**MANDATORY SERVICE BULLETIN Z 242L/63a**

- 2. APPLICABLE TO:** All Z 242L aircraft's from S/N 0741 incl. to S/N 0799 incl. with adjustable foot control.

Original clamp position:

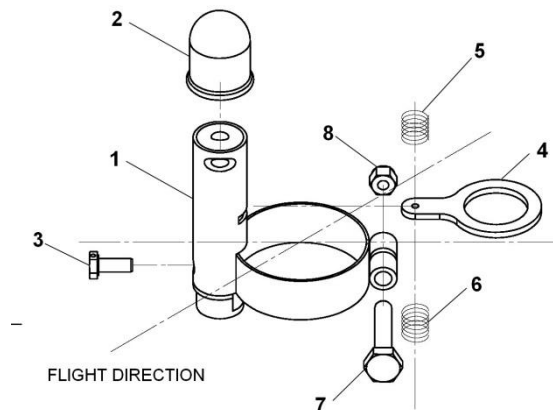
Inaccurate defining of the installed clamp in parking brake attaching clamp in the Maintenance Manual. During maintenance (disassembly and subsequent assembly of the clamp) could be improper adjusting and subsequent colliding clamp and rudder pedals when setting the rudder pedals to the front position.

- 8. PROCEDURES:**
  - a) Check the location of the attaching clamp in parking brake on left brake cylinder. In case of collision with the pedals rotate it into required position (see following figure). Verify no conflict in front and rear pedal control position.

Possible rotation of the clamp in the required position:
